**ASHLAND PLANNING COMMISSION
REGULAR MEETING
APRIL 10, 2012
AGENDA**

A. PLANNING ACTION: #2012-00018

SUBJECT PROPERTY: 2220 Ashland Street

ASHLAND PLANNING DIVISION
STAFF REPORT
April 10, 2012

SHEET TITLE:	
BUILDING A - RETAIL EXTERIOR BUILDING ELEVATIONS	
SHEET NO.:	
A-201

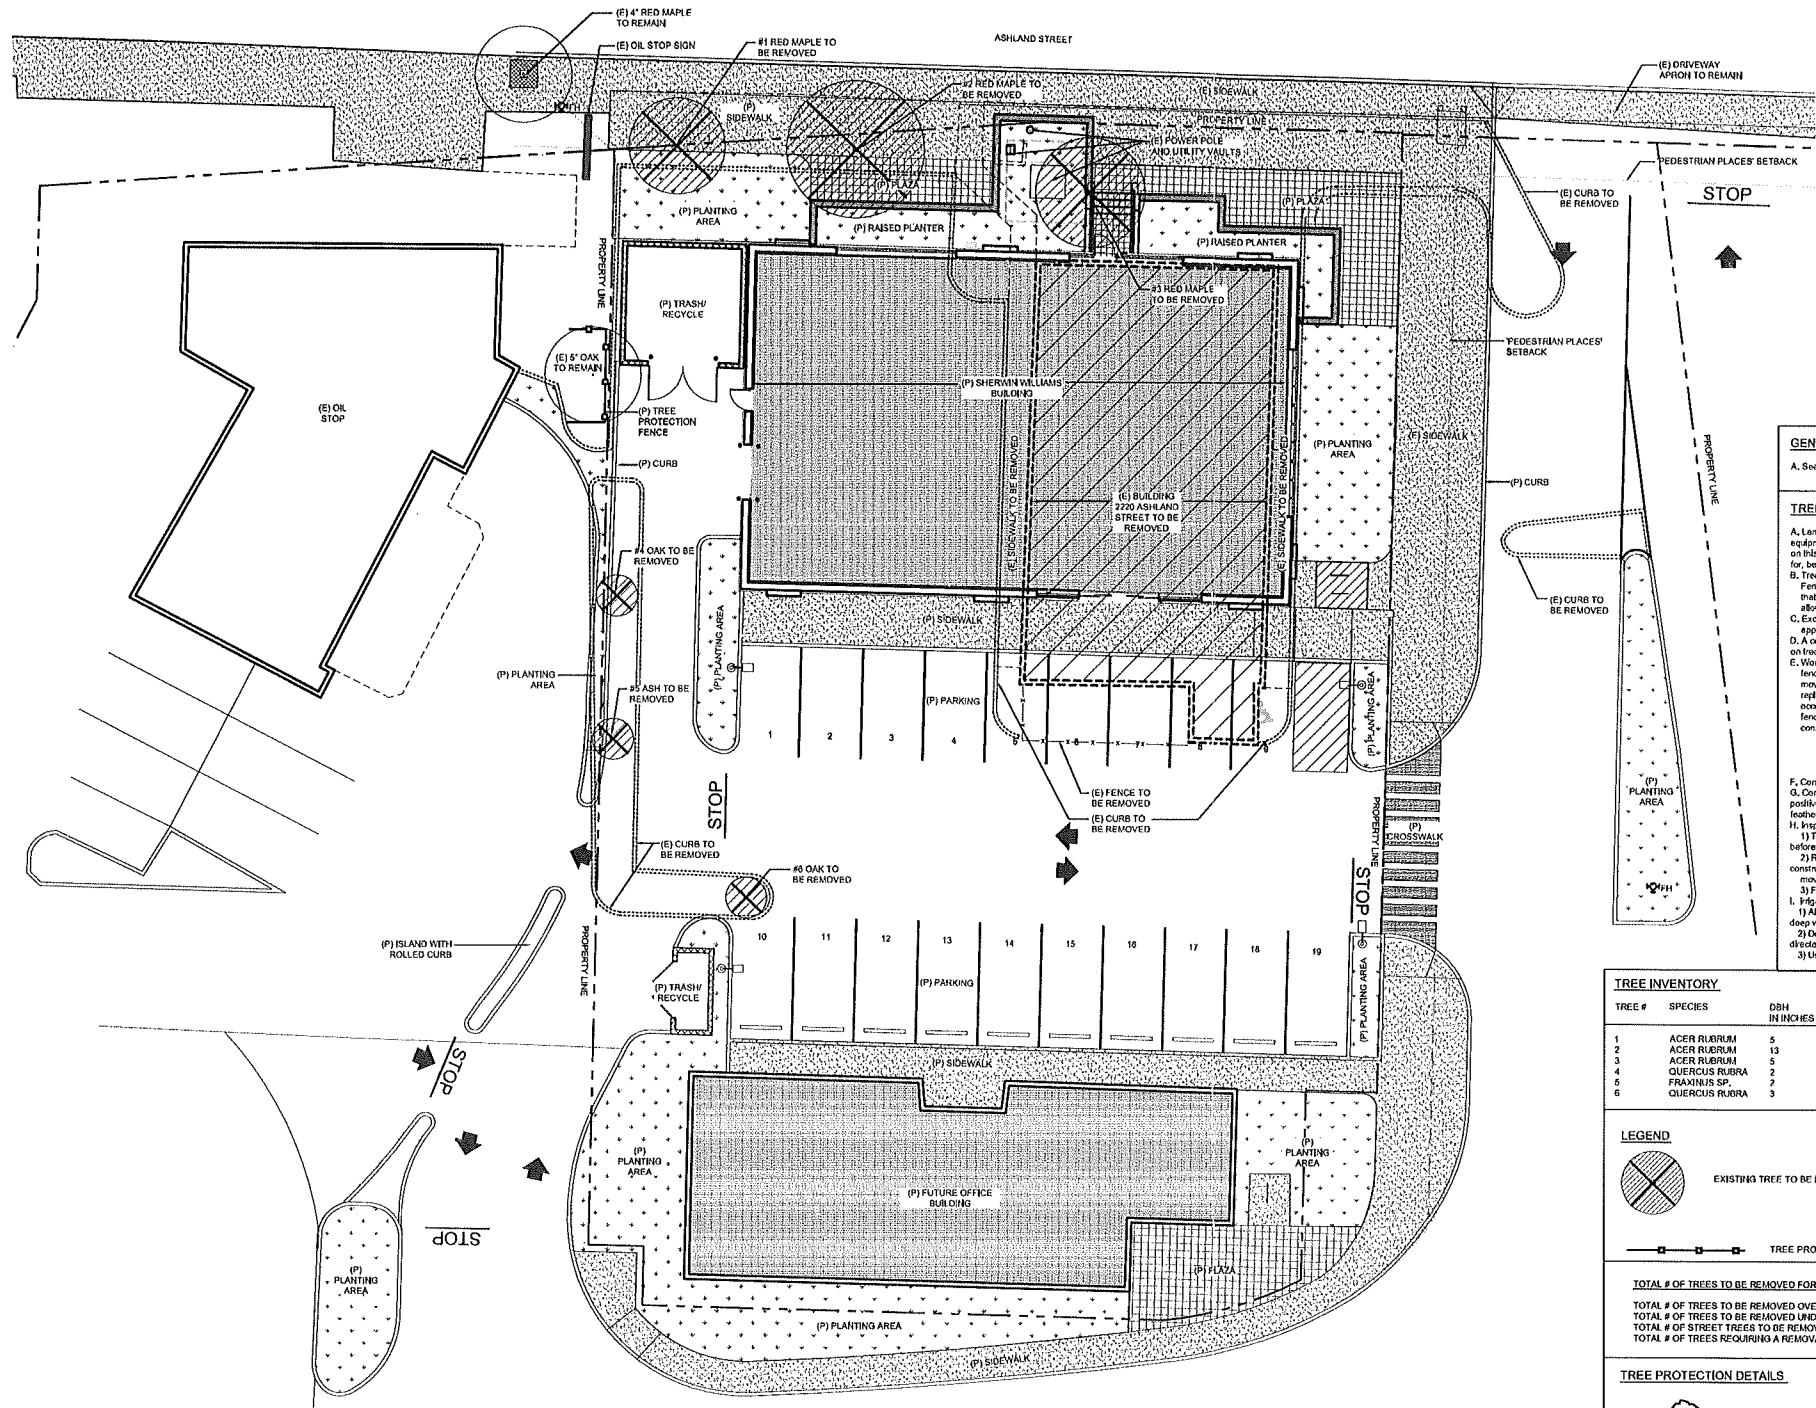
proposed there is an additional column of windows on the left side which gives the front entrance a lopsided appearance. The floor plan of the space has restroom facilities at the front of the building and an office at the rear. These restrooms appear to be the controlling factor for the window placement. The floor plan and the locations of the office space and the restrooms could be modified to allow for increased window area.

Staff Concern / Recommendation: The primary building orientation is directed to the parking area rather than Ashland St., and the street entrance is less prominent. Second column of windows adjacent to Ashland St. entrance create an off-center or lop-sided appearance. The building floor plan, through an adjustment of restroom location, could be modified in order to increase the window area facing Ashland Street consistent with the City's design expectation for the primary frontage.

There is a four foot wide awning proposed for the front of the building over the walkway from the sidewalk and plaza area over the landing for the entrance stairs. The awning extends for approximately twenty feet on either side of the entrance stairs. The awning covers just the landing of the entrance stairs and the planters between the building and the sidewalk grade plaza area. This awning does not provide protection for pedestrians from the rain and sun as required in the Detail Site Review.

Staff Concern / Recommendation: The current proposal does not adequately provide protection from rain and sun for the pedestrian plaza area. The awning shown on the building plans does not extend over the pedestrian plaza area. The application should address this either by extending the awning and creating covered outdoor spaces adjacent to the building and incorporating free standing trellis structures over outdoor spaces as noted in the City's Design Standards.

The attached plans, specifically Sheet A-201, have been revised in an attempt to emphasize the building's front elevation facing Ashland Street. The building elevations, as well as the plaza space improvements, should clearly "read" as the front of the building. The applicants desire to better engage Ashland Street in order to provide an attractive and inviting street façade and at the same time meet the tenant's needs for crucial display area. Overall, the applicants contend this standard is being met and remain excited about replacing the existing building and further enhancing Ashland Street.
